# SPRING ROAD TRIBUTARY RESTORATION - NEXT STEPS

Jedd Anderson  
Vice President  
Christopher B. Burke Engineering, Ltd.

# Change Order Request

## CHANGE ORDER #1

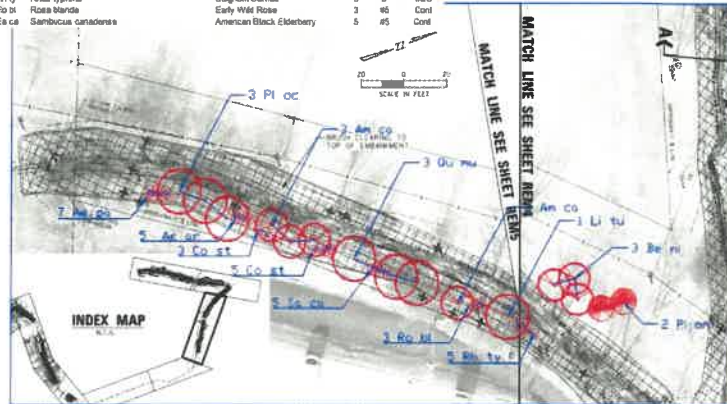
Step 1: Remove all buckthorn and honeysuckle, weedy brush, and **+/- 1" or less dbh trees/shrubs from remaining channel restoration areas**. Brush/trees (+/- 1" or less dbh) consists of buckthorn, honeysuckle, mulberry, elm, sumac, green ash, cotton wood, various vines, poison ivy, and other woody volunteer undergrowth below the tree canopy. Removal of small woody material is necessary to allow workers to complete the work. There are extensive areas of dense small diameter woody vegetation to be removed to allow work effort to be completed.

Removal will be completed on foot with power hand tools and manual hand tools, except for remaining trees in Kreml Park that must be removed for wall and boulder installation. Chippers will be used to dispose of cut material.

Trees greater than 1" dbh in areas that will not be in areas to be graded shall be saved for re-evaluation later. However, volunteer trees within the channel interior which impede flow will be evaluated for removal at the time of initial brush removal.

The locations for removal are all remaining areas identified on the project plans.

# Landscape Plan for Hodges

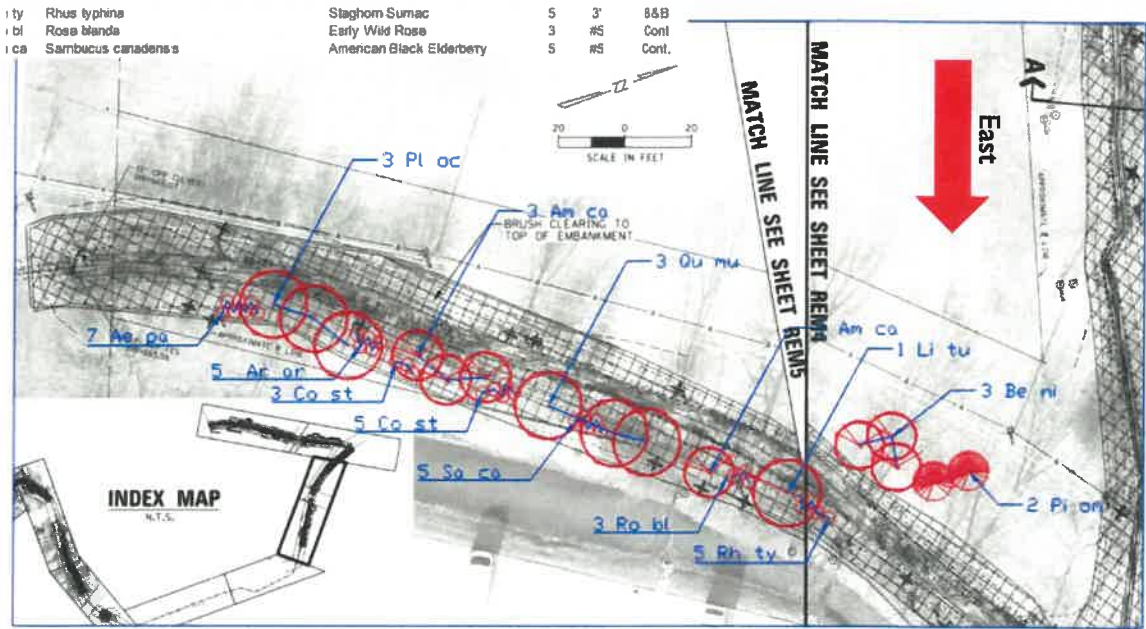
Step 1a: Tree and shrub planting plan for stream channel section north of Hodges to intersection with the side channel from Monterey Ave (outlined in red) (Draft plan prepared on September 8, 2022, and forwarded for review).

Approval of planting plan sought tonight.

## 16 Trees and 33 Shrubs
